FIELD REPORT

1103 Anderson Creek Lot Repair- Lot 1402 - 🎏 Education Dr.

Tuesday 10/01/2019

Please see sketch for DCP evaluation locations.

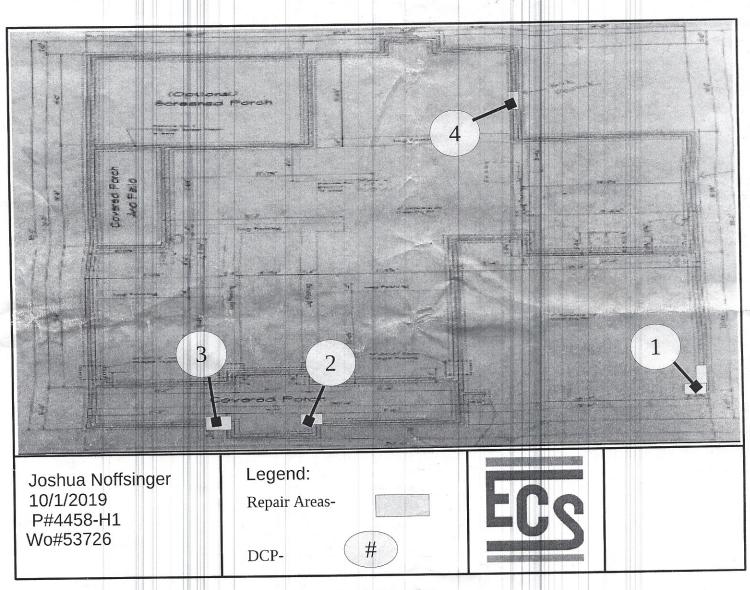
Location 1 was excavated approximately 3 foot below proposed bottom of footing and approximately 5'x6' area due to trash and debris. ECS recommends backfill the area with 57 or similar wash stone, or add a minimum of 1ft of additional concrete.

Location 2,3,4 are all stump removals going foot below proposed bottom of footing to about 3 wide in length and width. ECS recommends backfill the area with 57 or similar wash stone, or add a minimum of 1ft of additional concrete.
